Item Name: Crosstube Turning Detail

DART AEROSPACE LTD	Work Order: .149336
Description: Crosstube Assembly (206B High Fwd)	Part Number: D206-667-141
Inspection Dwg: D206-667-141 Rev: C	Page 1 of 2

DRAWING NO. D206-667-141	TITLE CROSSTUBE ASS'Y (206B HIGH FWD)	REV. C	DART AEROSPACE LTD ENGINEERING ORDER		D.E.O. NO. D206-667-141-C-1	SHEET NO. SHEET 1 OF 1	SCALE NTS
DRAWN <i>q</i>	CHECKED <i>ASS</i>	MFG. APPR. <i>AD</i>	APPROVED <i>MD</i>		DE APPR. <i>HA</i>		
DATE 11.07.15	DATE 11.07.20	DATE 11.07.21	DATE 11/07/21		DATE 11.07.21

DRAWING NO. D206-667-141		TITLE CROSSTUBE ASS'Y (206B HIGH FWD)		REV. C DART AEROSPACE LTD ENGINEERING ORDER		D.E.O. NO. D206-667-141-C-2		SHEET NO. SHEET 1 OF 1		SCALE NTS	
DRAWN AJS		CHECKED <i>[Signature]</i>		MFG. APPR. <i>[Signature]</i>		APPROVED <i>[Signature]</i>		DE APPR. <i>[Signature]</i>			
DATE 12.08.02		DATE 12.08.02		DATE 12.08.02		DATE 12.08.02		DATE 12.08.02

DETAIL P
BONDING STRAP INSTALLATION 2 PL

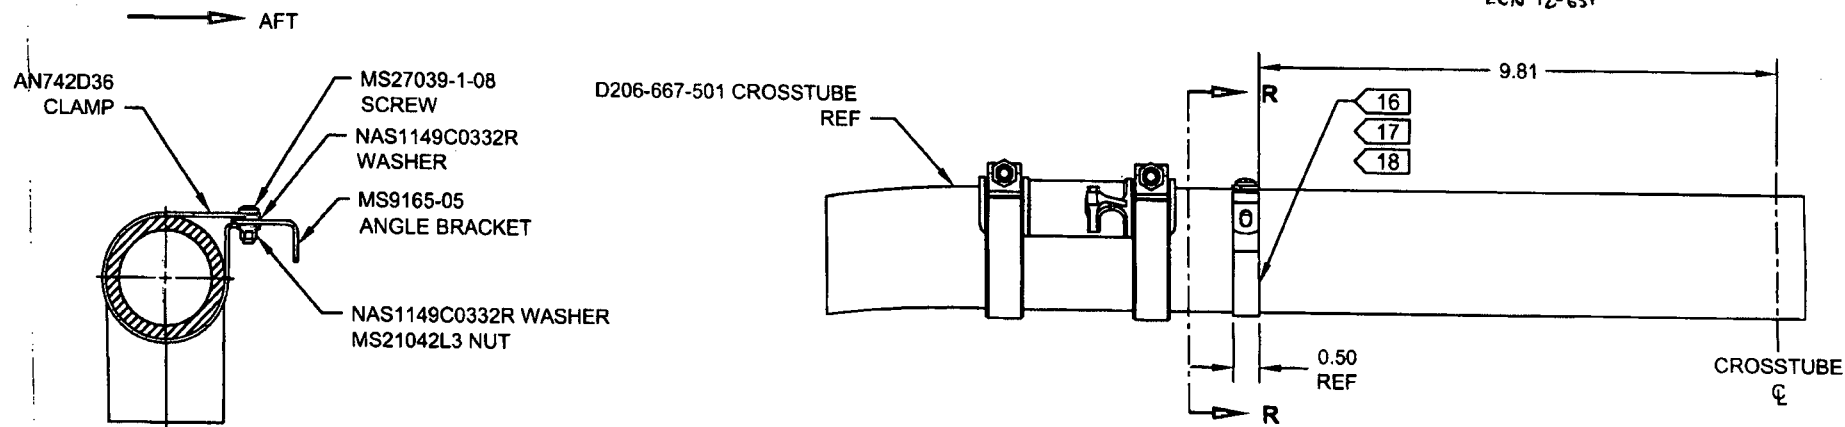
ADD ELECTRICAL GROUNDING STRAP

ITEM	QTY -141	PART NUMBER	DESCRIPTION	
1	X	D206-667-141	CROSSTUBE ASSEMBLY (206B HIGH FWD)	
10	2	AN742D36	CLAMP	] ADD
11	2	MS9165-05	ANGLE BRACKET	
12	2	MS21042L3	NUT (OR MS21042-3)	
13	2	MS27039-1-08	SCREW	
14	4	NAS1149C0332R	WASHER (OR AN960C10L)

- 16) MASK AREA UNDER CLAMP PRIOR TO PAINTING
- 17) SEAL EDGES WHERE AN742D36 CLAMP MEETS WITH THE CROSSTUBE USING SIKAFLEX-241/-291 OR MIL-S-8802 CLASS B2 OR PROSEAL 890 SEALANT
- 18) PERFORM RESISTANCE CHECK TO ENSURE MAX RESISTANCE IS 10 MILLIOHMS
